SUBJECT: Savannah River Site's Responses to the Regulatory Comments on the Performance Evaluation Report for the A-Area Burning/Rubble Pits (731-A, -1A) and Rubble Pit (731-2A) and the Miscellaneous Chemical Basin/Metals Burning Pit (731-4A, -5A) Operable Unit - January through December 2022 (U) (SRNS-RP-2023-00127, Revision 0, May 2023) SEMS Number: 28

SRS Responses to U.S Environmental Protection Agency Comments on the Performance Evaluation Report for the A-Area Burning/Rubble Pits (731-A, -1A) and Rubble Pit (731-2A) and the Miscellaneous Chemical Basin/Metals Burning Pit (731-4A, -5A) Operable Unit – January through December 2022 (U), SEMS Number: 28 (SRNS-RP-2023-00127, Revision 0, May 2023)

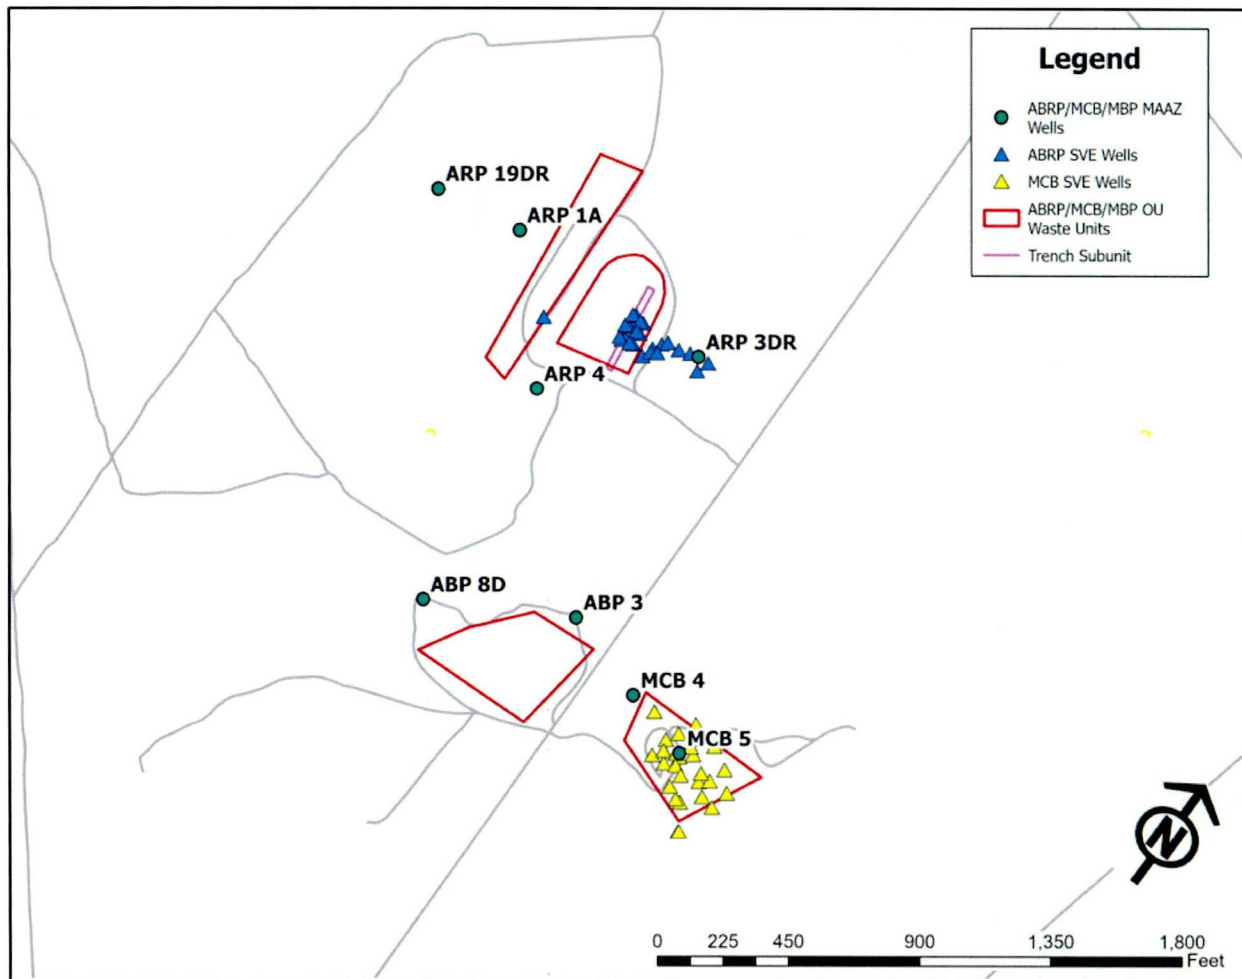
4. **Section 4.3, Overall Recommendations, Page 11 of 52:** The text states “The MAAZ monitoring wells in the area are below respective MCLs for PCE, also indicating no impact to the water table for these units”; however, TCE concentrations exceeding the MCL in two of eight ABRP MAAZ wells are not discussed. According to Section 1.3, the MAAZ wells near the ABRP source have decreasing VOC trends indicating mass depletion of the source. *Please revise the text to discuss the TCE groundwater results that exceed the MCL and how this relates to mass depletion of ABRP source.*

VOC mass in the vadose zone can migrate through the vadose zone by gravity-driven (i.e., source loading and infiltration) and diffusive forces. With source loading eliminated and infiltration reduced by the placement of caps, VOC mass remains in the pore space of the vadose zone with the potential to impact groundwater over time. SVE helps to remove the VOC mass in the vadose zone, reducing the potential impact to groundwater. With little to no VOC mass impacting the groundwater, VOC concentrations in the groundwater decline with time. Monitoring wells ARP 3DR and MCB 5 are located within the footprint of the SVE systems at the ABRP trench subunit and MCB, respectively. As described in the response to EPA specific comment #1, the VOC concentrations in these wells have declined since the SVE systems started operations. No change to the current report is proposed.

Attachment 2. PCE and TCE Time Series Graphs for ARP 3DR.

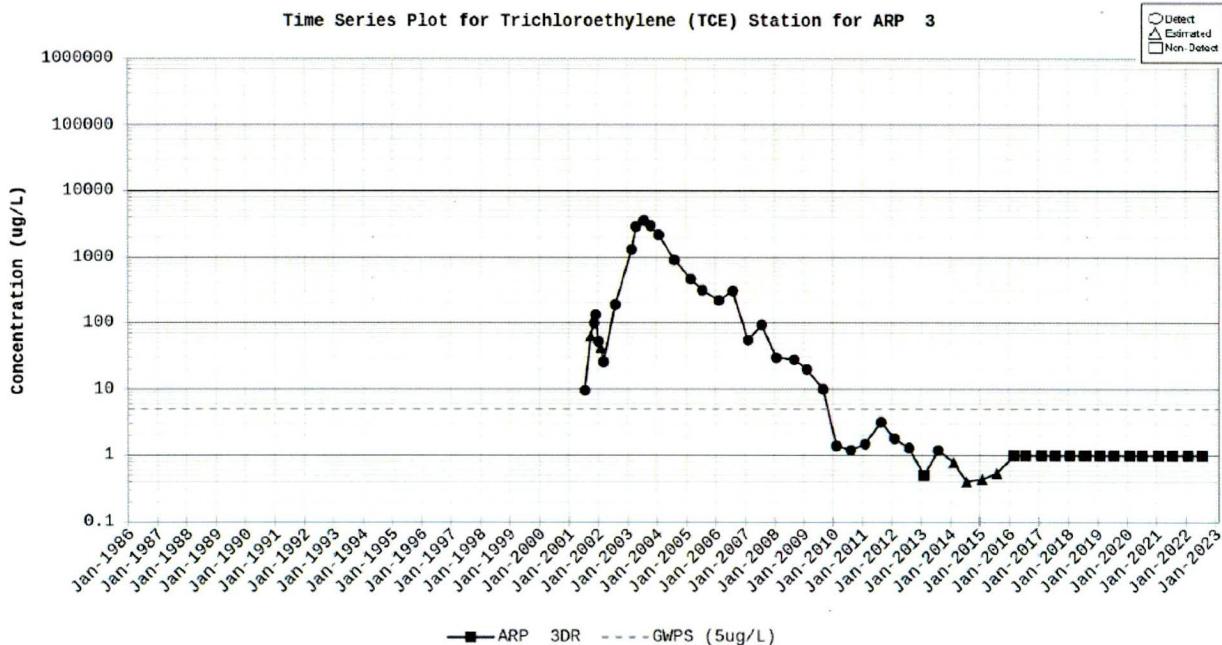
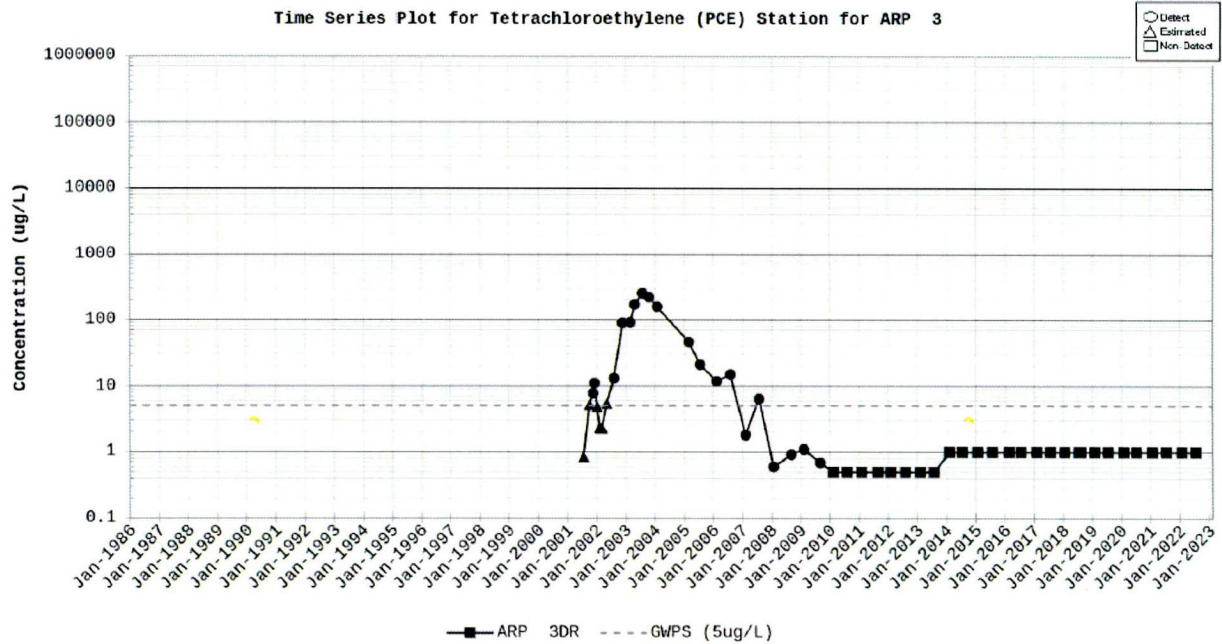
1. **Section 1.3, Groundwater, Page 2 of 52, and Table 1, ABRP/MCB/MBP OU Subunit Remedial Actions and Regulatory Decision Documents, Page 28 of 52:** The information in Section 1.3 and Table 1 indicates TCE concentrations will be below the maximum contaminant level (MCL) in the near future in two of eight MAAZ wells where TCE exceeded the MCL; however, there is no information (e.g., concentration trend data) presented as a supporting line of evidence that these concentrations will be below the MCL in the near future. Therefore, the effectiveness of the vadose zone remedial action (RA) on reducing TCE concentrations in the MAAZ is unclear. *Please revise the text to provide additional information (e.g., concentration trend data) regarding the TCE results for the two MAAZ wells located near the ABRP subunit source as a line of evidence to support vadose zone RA effectiveness.*

For reference, the PCE and TCE time series graphs for monitoring wells ARP 3DR and MCB 5 are provided as Attachments 2 and 3 to these comment responses. Because of their location within the footprint of the SVE systems, ARP 3DR and MCB 5 are the monitoring wells that best demonstrate the effectiveness of the SVE systems on depleting VOC mass from the vadose zone. At ARP 3DR, PCE and TCE concentrations declined sharply in 2003, likely in response to the operation of active SVE starting at ABRP in 2001. PCE and TCE concentrations continued to decline after 2003 and have been below detection limits and less than the maximum contaminant level (MCL, 5 µg/L) since 2010 for PCE and 2016 for TCE. At MCB 5, PCE and TCE concentrations started to decline after 2001. PCE and TCE concentrations declined much slower at MCB 5 considering SVE started in 1997. PCE concentrations have been less than the MCL since 2009 with a concentration of 0.6 µg/L in 2022. The TCE concentration at MCB 5 declined from 2001 to 2016. From 2016 through 2020, the TCE concentration increased slightly but has since declined in 2021 and 2022. In 2022, the TCE concentration at MCB 5 was 9.9 µg/L.
